This is a follow-up letter to our previous letters regarding the Survey of the BAGONG LIPUNAN Subdivision Project of Sta. Monica BLCA INC. of Puerto Princesa City. I hereby request your good Office to please help the Association to provide us the correct Technical Description of Lot 4203 - Cad-800-d, Puerto Princesa City Cadastre since it was already known to me and to all of us that the Approved TD in the Regional file are erroneous. I have already Submitted subdivision survey for approval several times but disapproved by your office on the ground that my survey returns do not conform to the Cadastral Technical Description.

To support our request for the cancellation of the **Subdivision Plan CSD-04-024890-D** and the Cadastral Map of **LOT 4203 CAD 800-D** and the adjacent lots Puerto Princesa cadastre which I have submitted on **Feb. 9, 2015**, I hereby submit my investigation survey report.

LOT 4203 CAD-800-D

EXHIBIT "A"

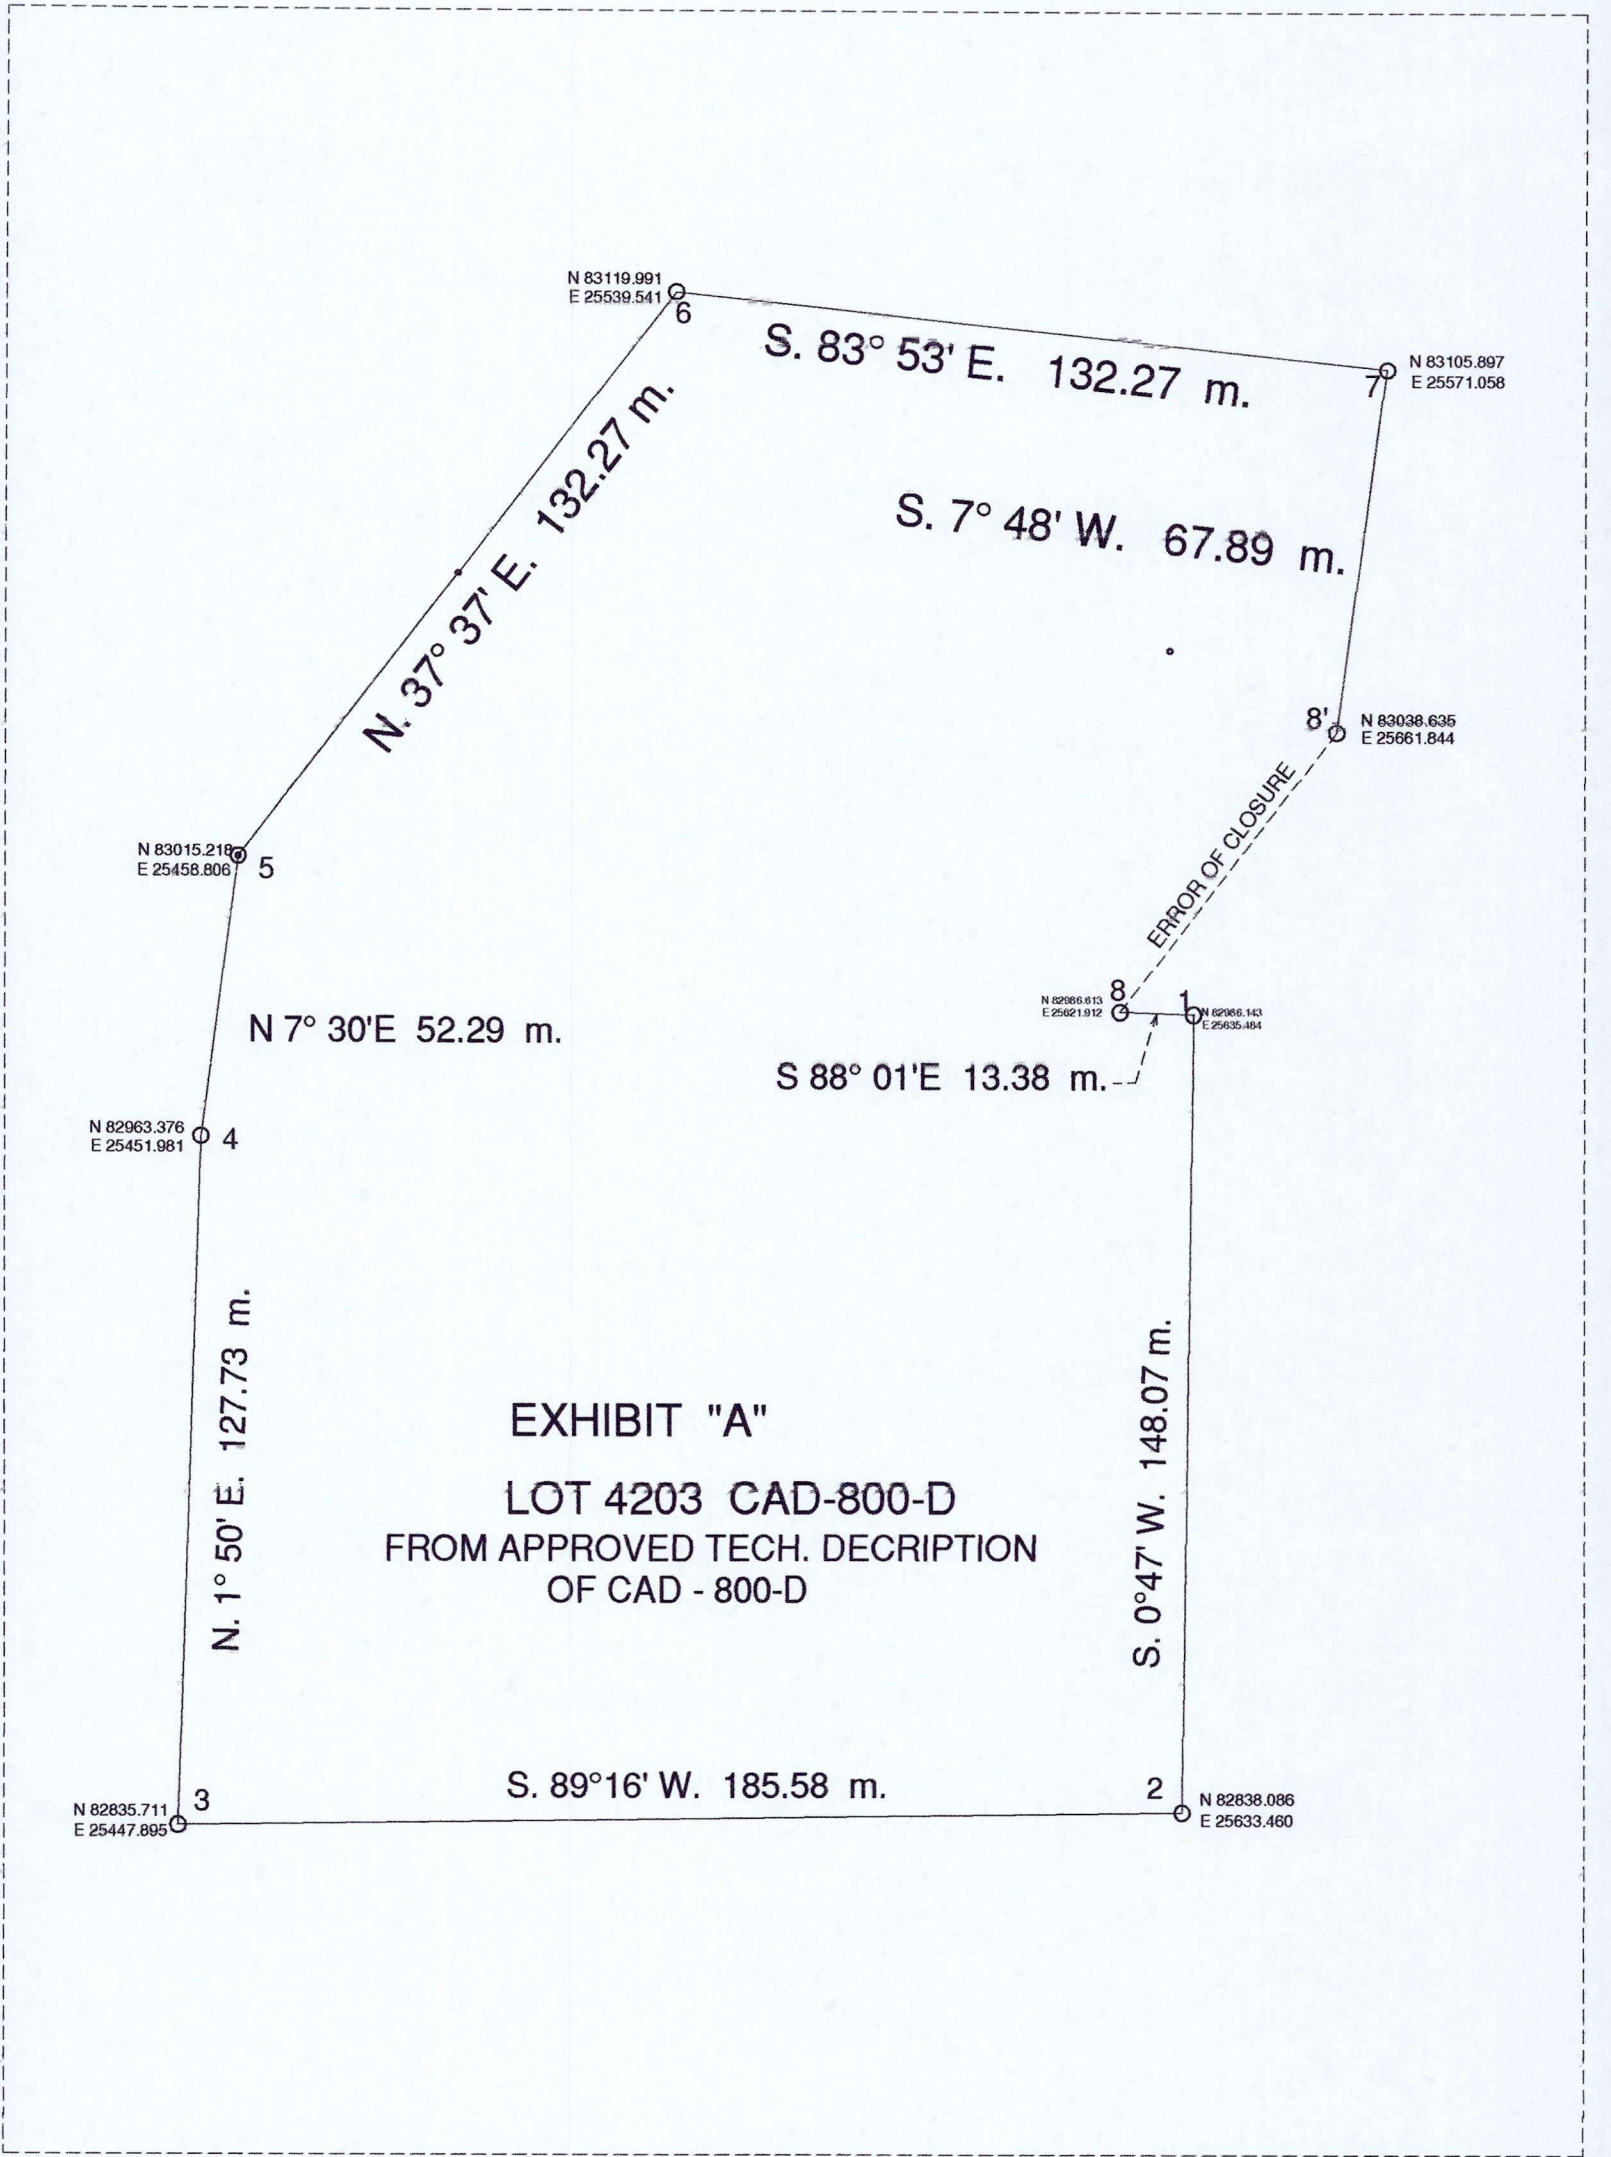
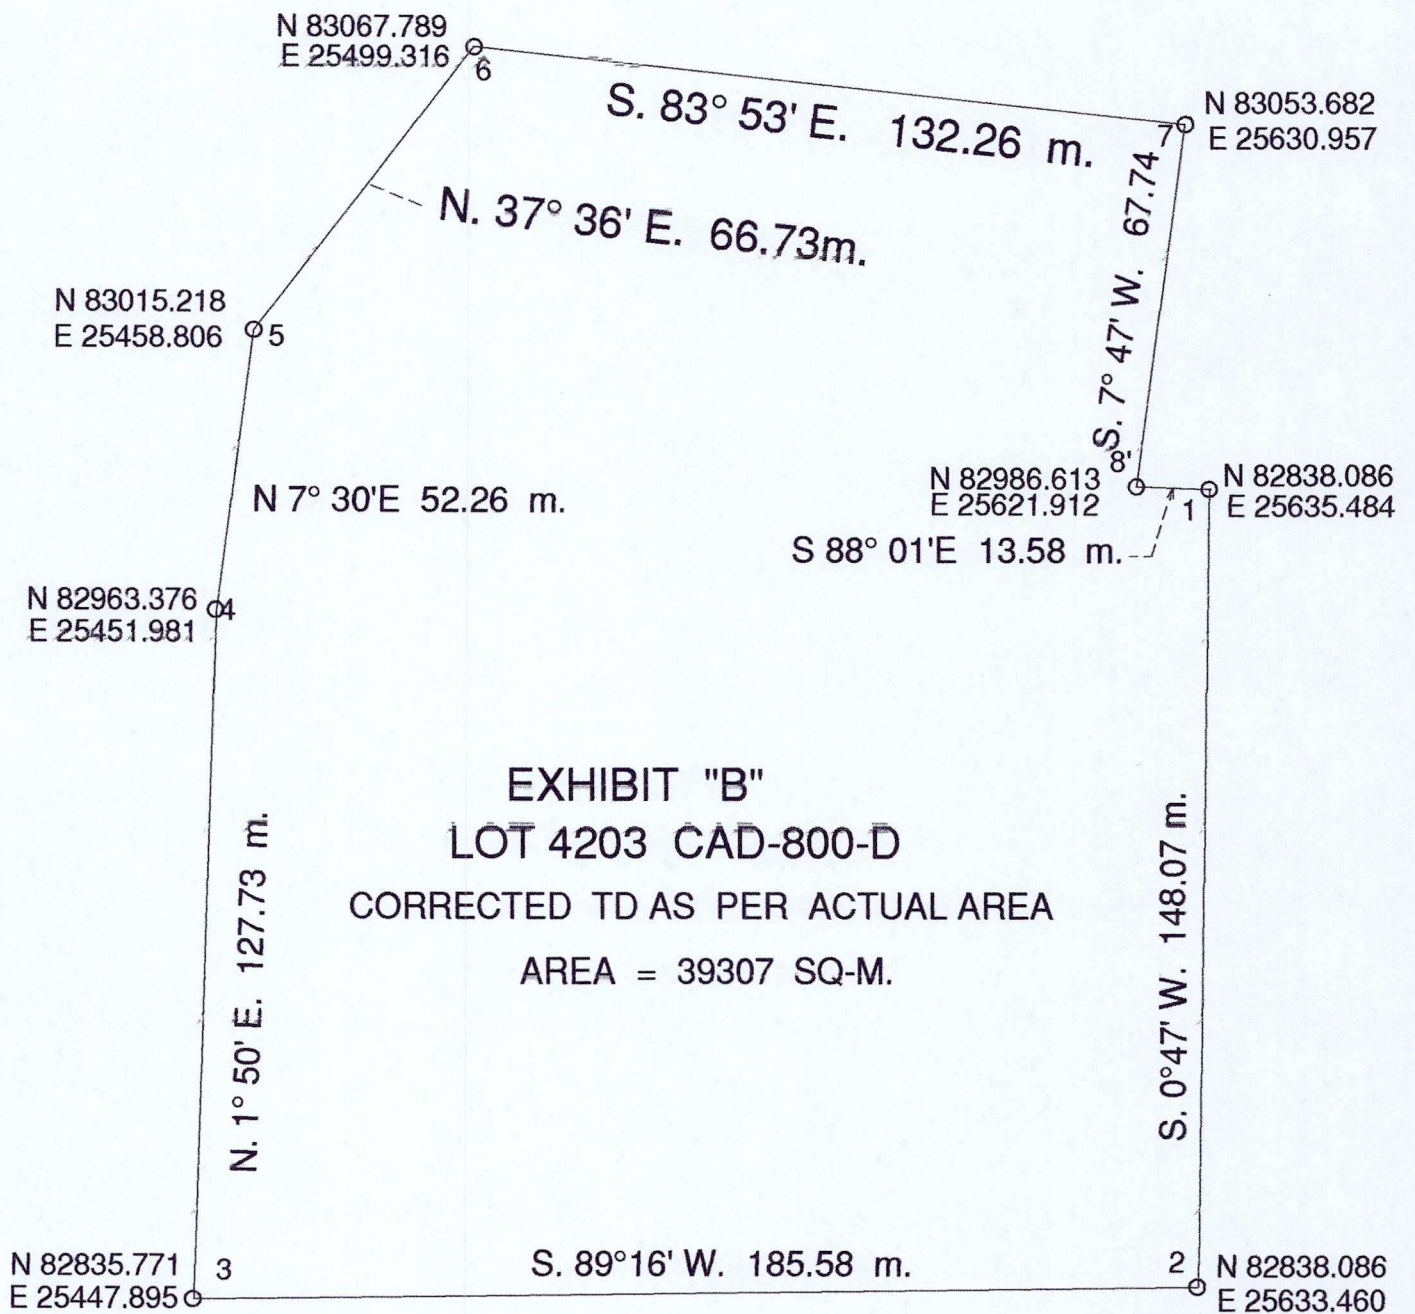
Attached herewith is the cadastral Technical Description And the open polygon that it described and marked as exhibit "A". (APPROVED CADASTRAL FILE OF TD AND MAP IN THE REGIONAL OFFICE) Also attached is the Technical Description of the Lot 4203, according to the actual Lot position as a result of my survey and investigation marked as exhibit "B" and that you may adapt or may approve or rectify.

1. The **Lot Description of Lot 4203 CAD-800-D** as submitted with the approve plan does not tally or conform with its corresponding lot data computation and cadastral plan.
2. **Lot 4108** of the same cadastral map has seven corners while in its lot data computation, it has five corners. Please take note also **the distances of the side 1-2 and 5-6 of lot 4108** are far longer in the lot data computation.

To plot this lots/block on the north of **Lot 4203** using lot data computation, the entire road separating this block and **Lot 4203 of BLCA** will be totally encroached by this block.

May I therefore reiterate my request for the cancellation of the subdivision plan **CSD-04-024980-D** and disregard or void the cadastral map/lot data computation.

Furthermore, may I also request the approval of the **Subdivision Plan of Lot 4203** which I have submitted based from the actual survey I made.
